Access Compliance Report

Public Rights-of-Way

(Pedestrian Signals)

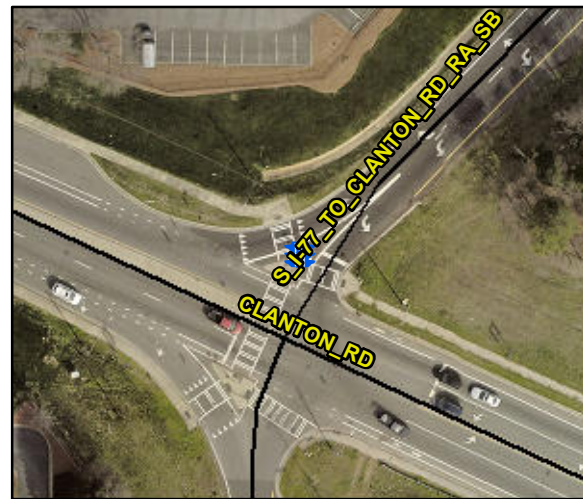
Surveyor Notes: TEXT HT 3/8

PROW/ADA: TMUTCD 4e.08, R410.6, R404.1, R404.7.1, R404.7.2

No	B 1 Clear Xing Direction?	NotClearlyMarked	N/A	B 2 Clear Xing Direction?	N/A
	B 1 Crossing Direction	To SW		B 2 Crossing Direction	N/A
Yes	B 1 DistanceTo XWalk (in)	0.0	N/A	B 2 DistanceTo XWalk (in)	N/A
No	B 1 DistanceTo Curb (in)	151.0	N/A	B 2 DistanceTo Curb (in)	N/A
Yes	B 1 Diameter (in)	2.0	N/A	B 2 Diameter (in)	N/A

Possible Solutions: Replace Signal Push Button With APS Button on New Post. Remove & Replace Sign.
